Exhibit A: 02/05/16: Tier 1 Project Revisions

CANDLESTICK POINT
Proposed Project Revisions Associated with Development Plan Application for Sub-Phase 02-03-03 and Updates to Project Documents, Including:
CP Major Phase 1 Application, CP Design for Development (D4D),
CP Streetscape Master Plan, CP-HPS-Phase 2 MMRP, CP Transportation Plan

CANDLESTICK POINT
Tier 2 and Tier 3 Revisions Associated with Development Plan Application for Sub-Phase 02-03-03 and Updates to Project Documents, Including:
CP Major Phase 1 Application, CP Design for Development (D4D),
CP Streetscape Master Plan, CP-HPS-Phase 2 MMRP, CP Transportation Plan

Exhibit E: Candlestick Center Hotel Height Visual

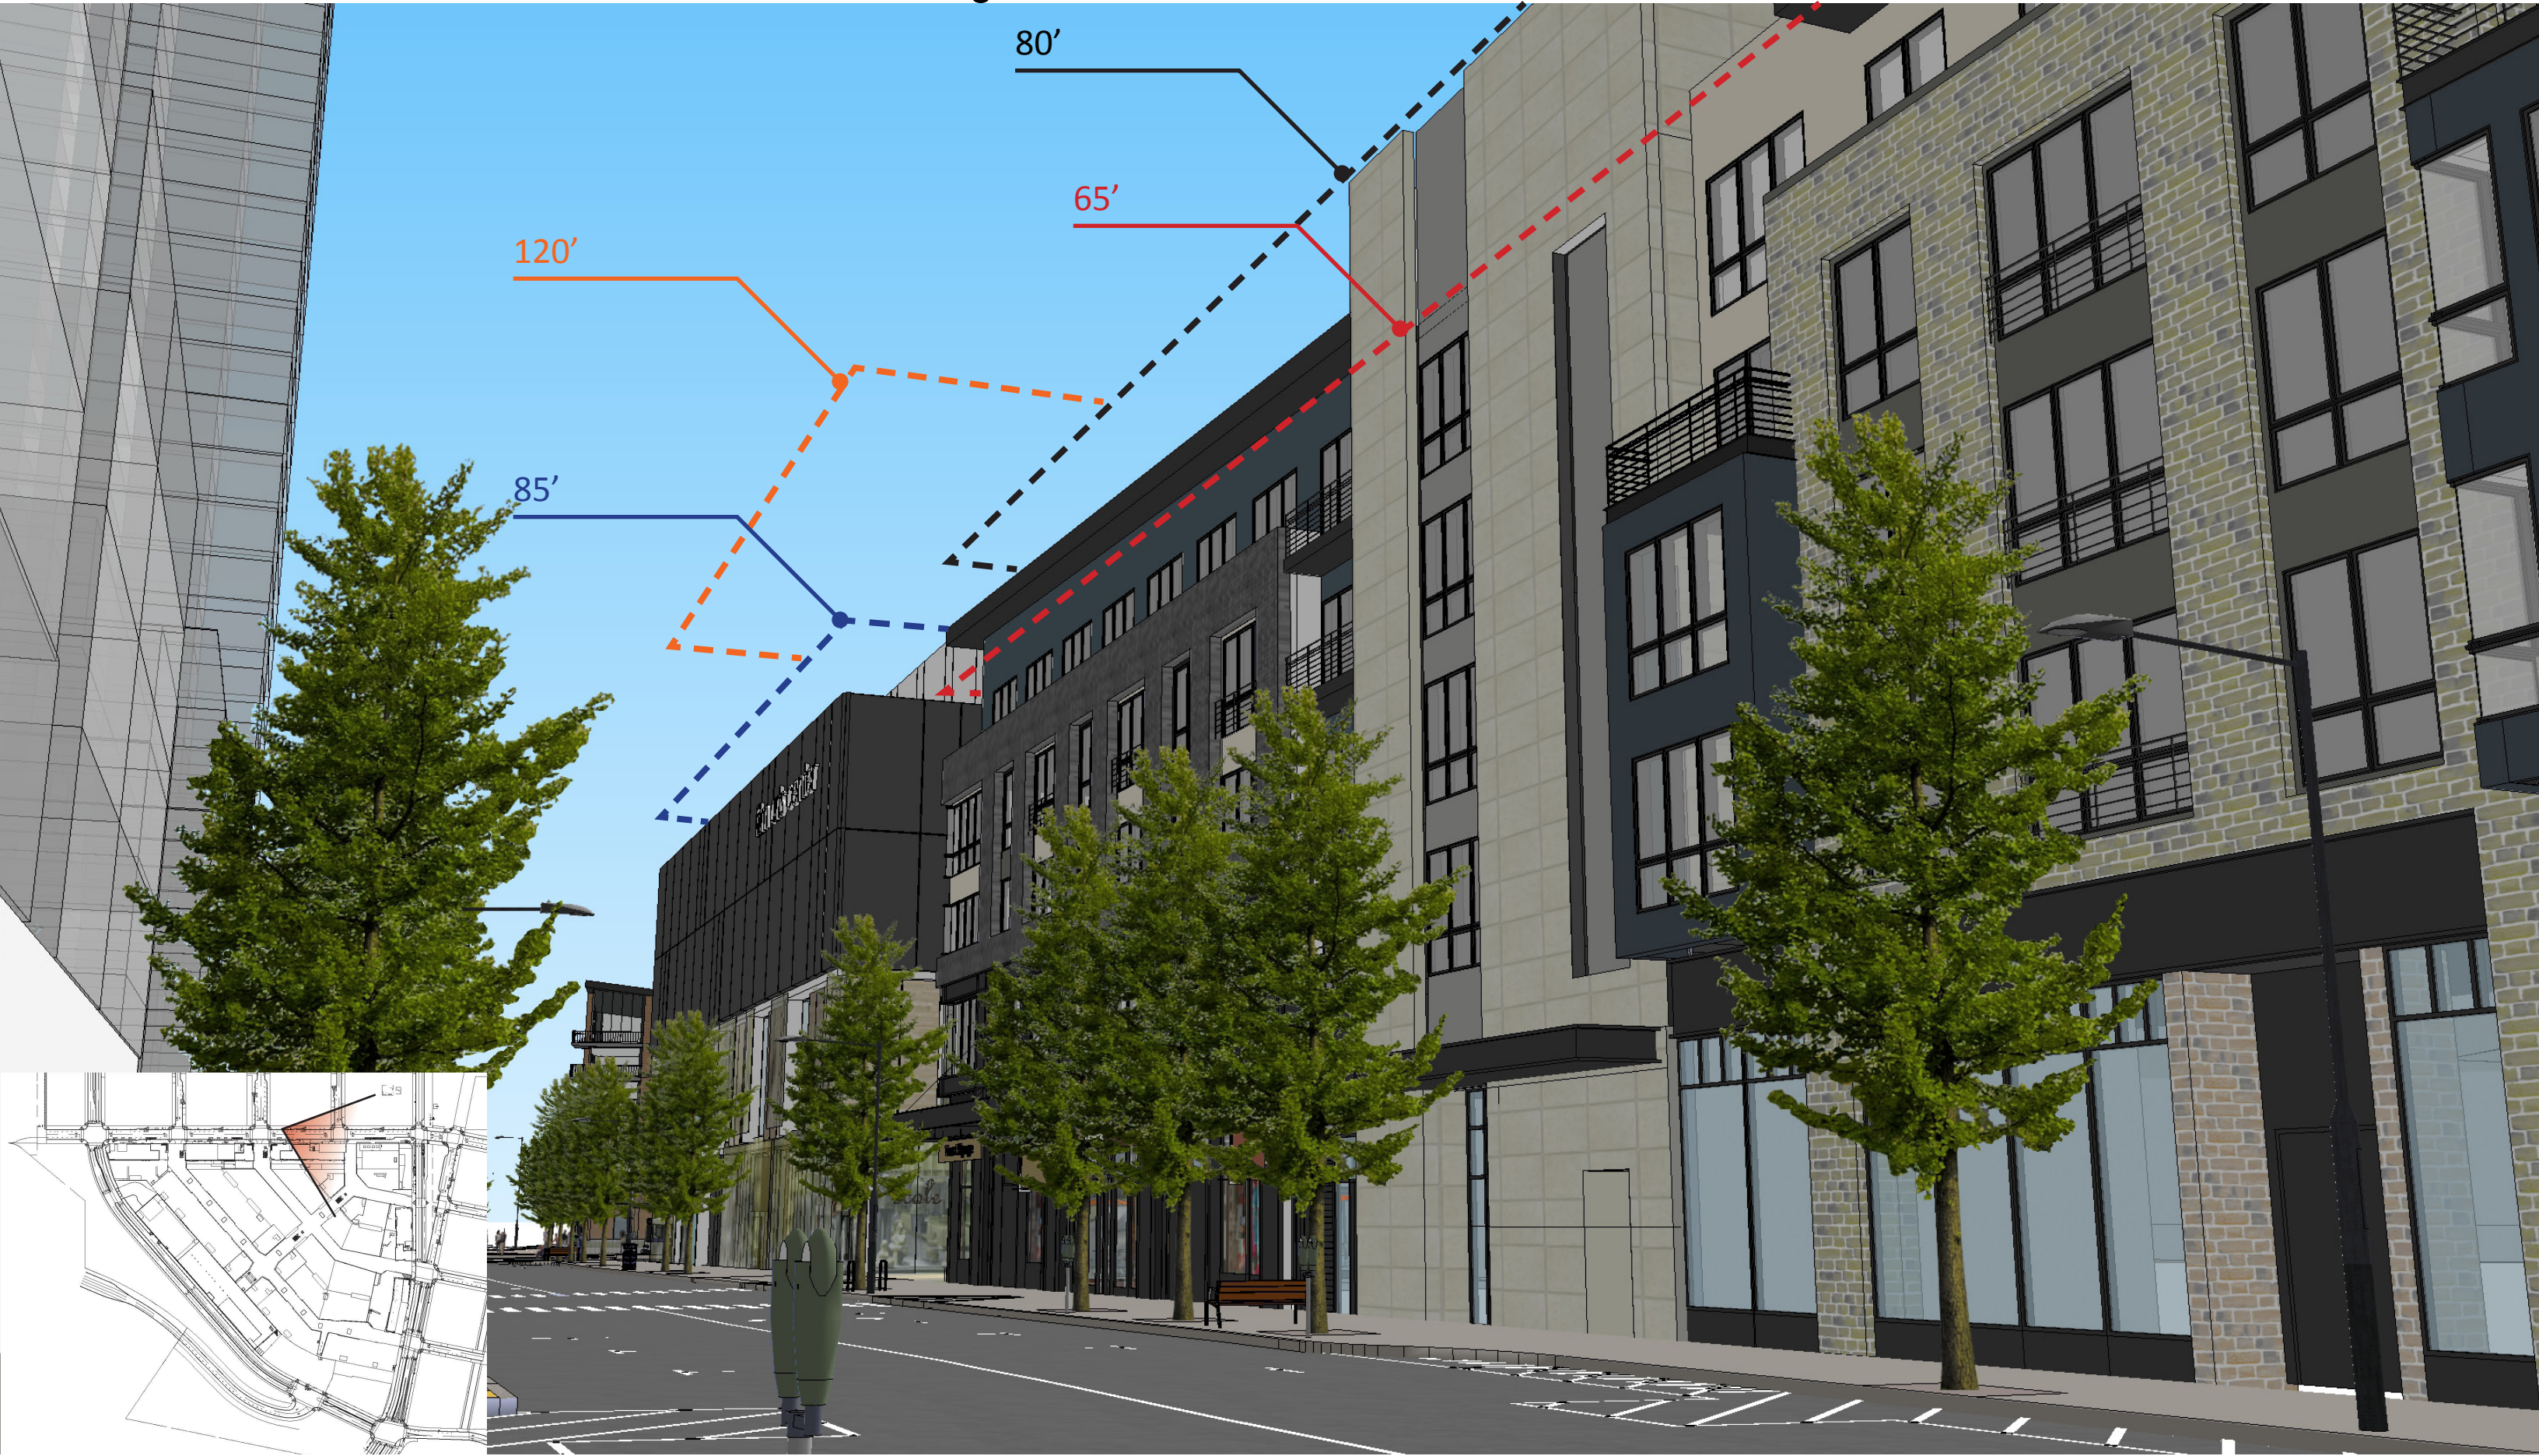
Proposed Revision	Existing Provision	Project Document(s) Revision
TIER 1: Substantive Project Revisions		
1. <u>Tower Relocation</u> : The sub-phase application proposes relocating Towers G, J and K. Tower G would be relocated within CP-02, but outside the approved tower zone. Tower J and K would be moved approximately 100 feet southeast. Tower K would remain in an approved tower zone and Tower K would be in a new fixed location.	D4D located Tower G in the approved tower location in the center of CP-02. D4D located Towers J and K in CP-South, approximately 100 feet north of the proposed location.	Major Phase 1 Application <ul style="list-style-type: none">• Section 1.1• Figure 6.1• Figure 6.5• Figure 6.6• Figure 6.7• Figure 6.8 D4D: <ul style="list-style-type: none">• Table 4.3• Figure 4.3• Figure 8.1

Harney Way Interim Configuration – Phase 1

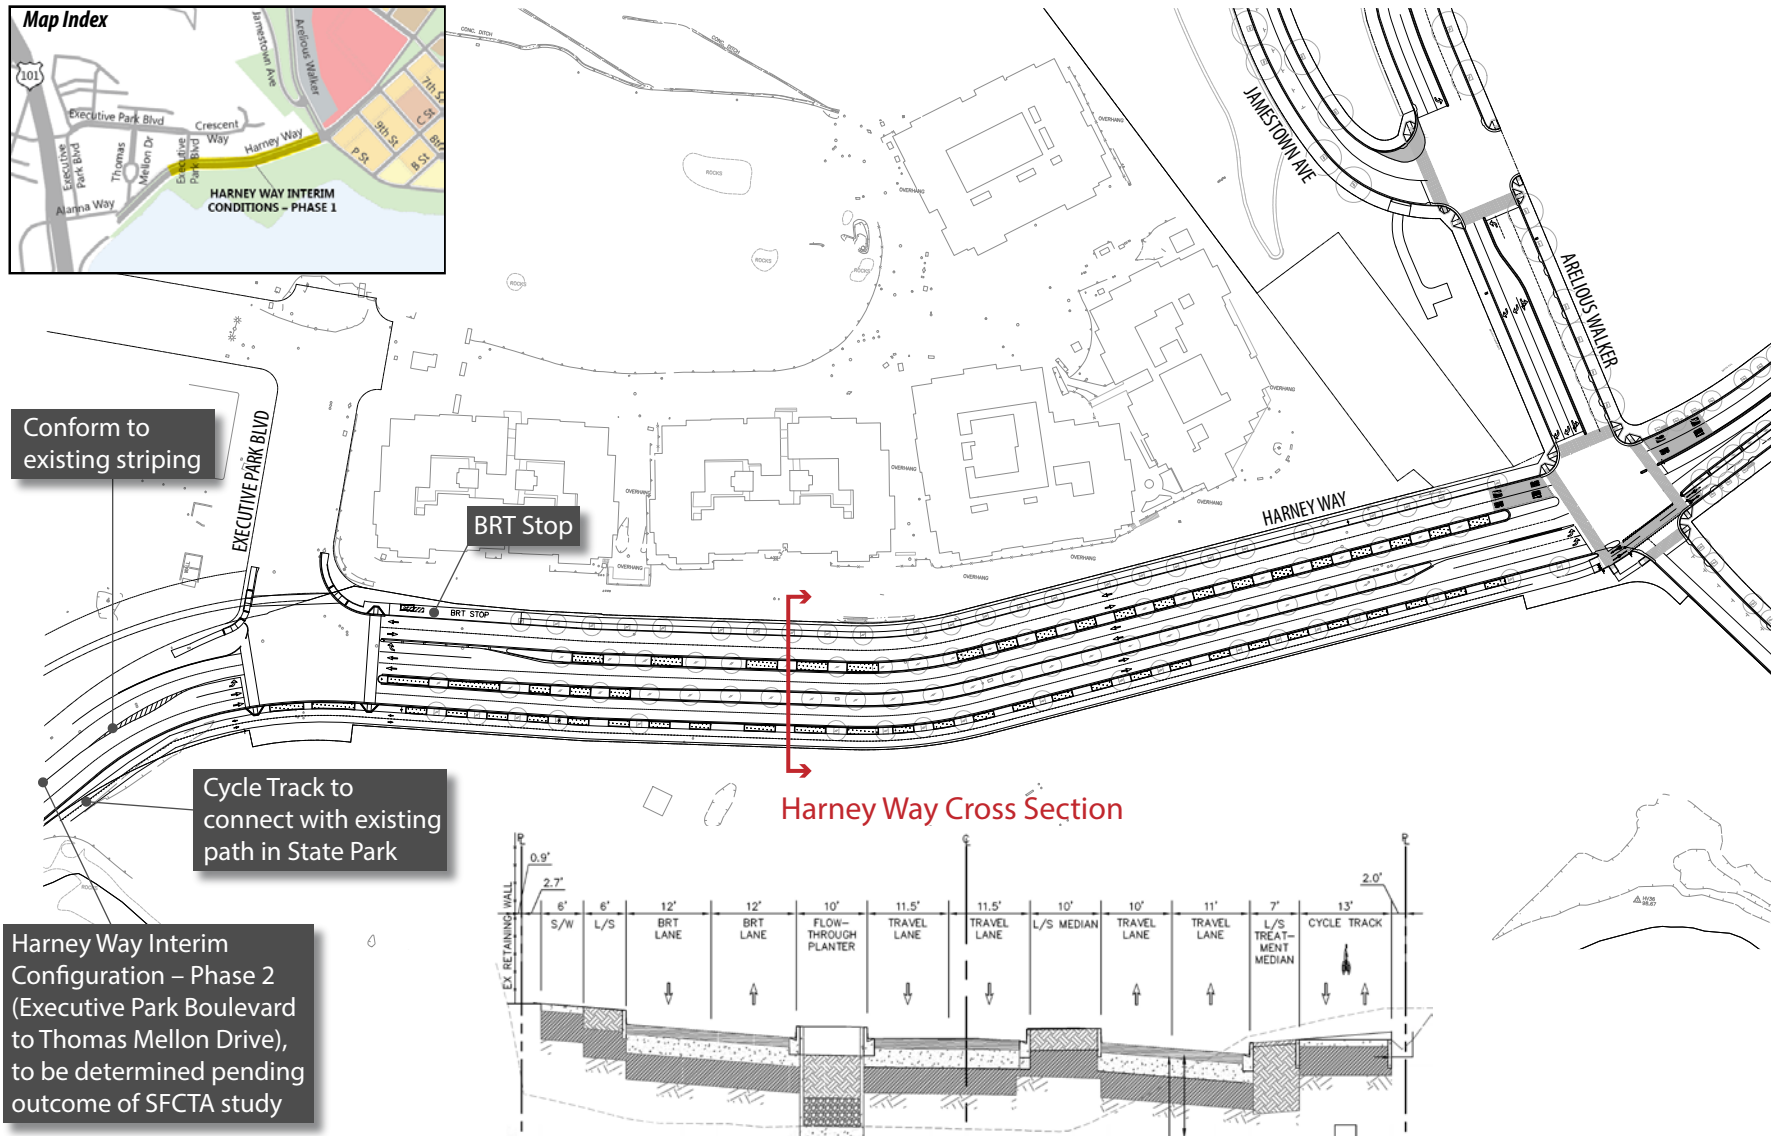
<p>7. <u>Harney Way Revised Off-Site Phasing:</u> The sub-phase application proposes to divide construction of the off-site Harney Way roadway improvements into two phases: 1) from Arelious Walker Drive to Executive Park Boulevard East, and 2) from Executive Park Boulevard East to Thomas Mellon Drive. The sidewalk and cycle track along Harney Way would be completed as originally the planned from Arelious Walker Drive to Thomas Mellon Drive.</p>	<p>First phase of Harney Way improvements extended to Thomas Mellon Drive.</p>	<p>Major Phase 1 Application</p> <ul style="list-style-type: none">• Section 1.1• Section 2.5• Section 8.1 <p>MMRP:</p> <ul style="list-style-type: none">• MM-TR-16 <p>Infrastructure Plan:</p> <ul style="list-style-type: none">• Section 2.1.3 A• Figure 2.1.3
<p>8. <u>Gilman Avenue Revised Cross Section:</u> The sub-phase application proposes to revise the cross section configuration to retain 15-foot sidewalks and on-street parking on both sides of street. Only one travel lane in each direction and a center turn lane would be provided.. The intersections between Third Street and Arelious Walker would be signal controlled.</p>	<p>Two lanes of travel in each direction; on- street parking on both sides of street; 12-foot sidewalks. All-way stop sign at the intersections between Third Street and Arelious Walker.</p>	<p>Major Phase 1 Application</p> <ul style="list-style-type: none">• Section 1.1• Section 8.1 <p>MMRP:</p> <ul style="list-style-type: none">• MM-TR-23.1 <p>Transportation Plan:</p> <ul style="list-style-type: none">• Figure 7M <p>Infrastructure Plan:</p> <ul style="list-style-type: none">• Section 2.1.3 E• Figure 2.1.5

Figure 1
Proposed Cross-Sections: Gilman Avenue

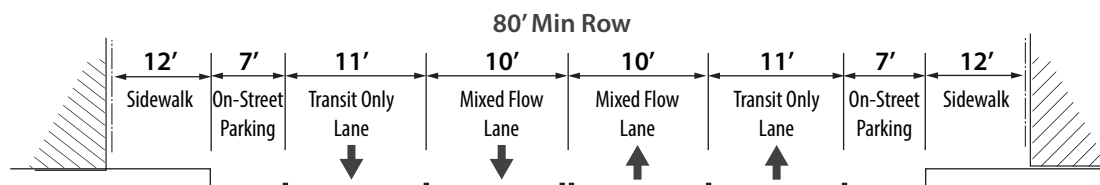
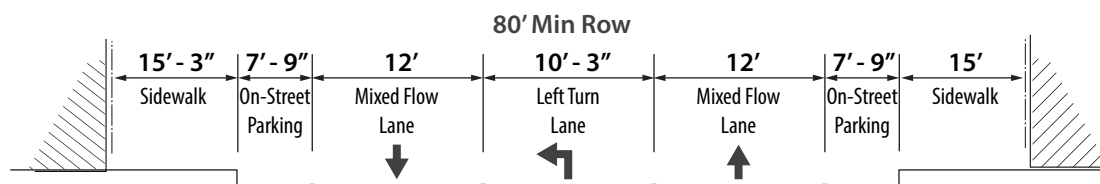
street cross section more symmetric, providing on-street parking on both sides and two travel lanes in each direction. Sidewalks would be narrowed from 15 feet to 12 feet. The originally-proposed configuration is shown in in **Figure 1(A)**. At some point in the longer-term future, one of the travel lanes in each direction may be converted to transit-only as part of a mitigation measure for project impacts to transit travel times, as shown in **Figure 1(B)**.

CP Retail Center Parking Garage Site Plan

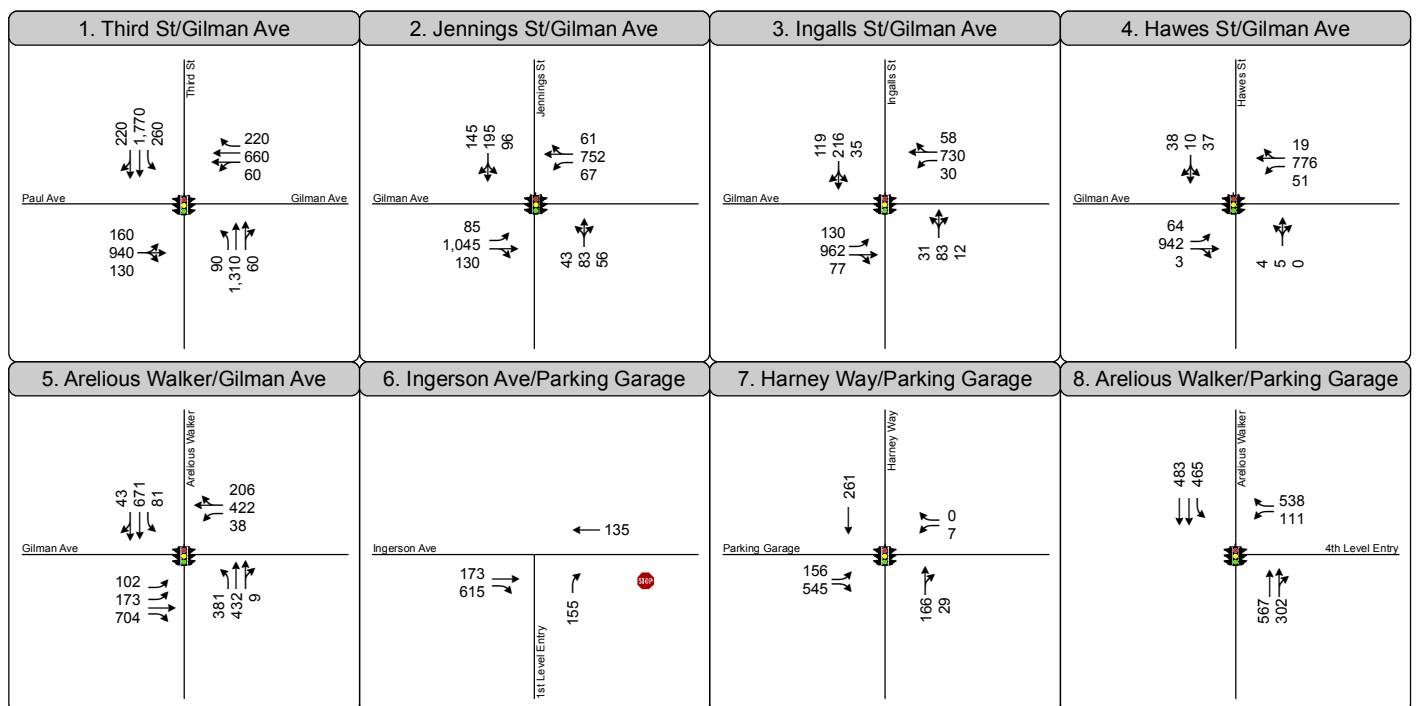
Figure 3 shows the latest parking garage design and four access points.
